SYSTEM/MODEL: LEF

MODIFICATION: Installing a volume control on an LE series sub station

VOLUME CONTROL ON A SUB STATION

LEF Mod. #0798-1306
Sch #1190-1306

LE-A Schematic Diagram

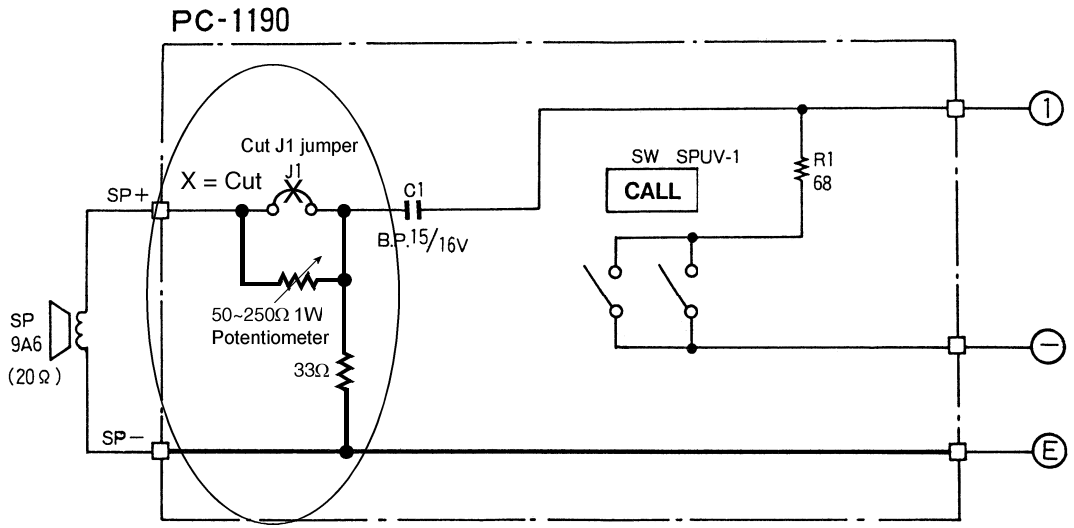
INSTR/OPERATIONS: 1. Install components as shown on the diagram.

2. No physical provisions are made on the sub station for the addition of a volume control. Chassis modification is required.

LE-AN Schematic Diagram

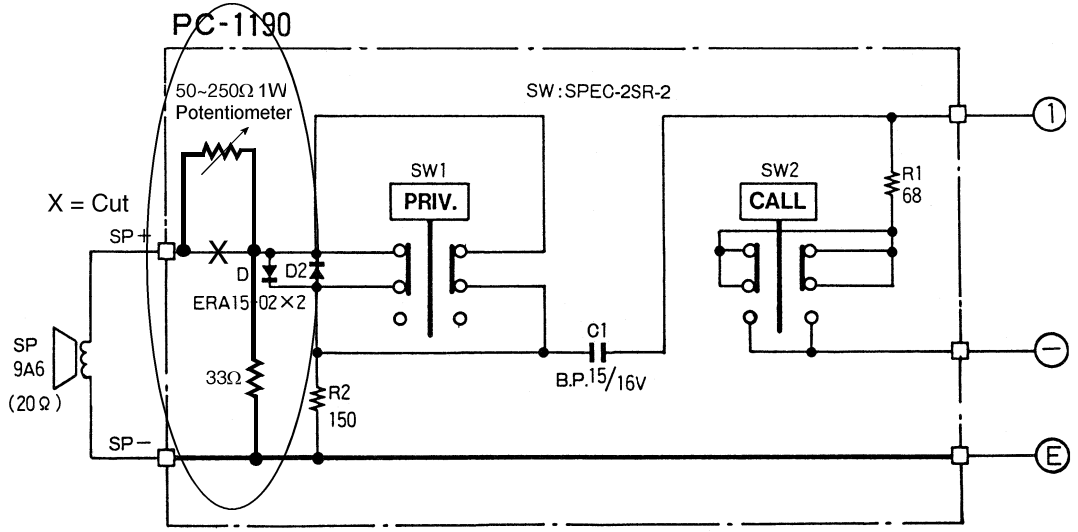
Add components as shown.
Volume control will affect communication and call tone volume.
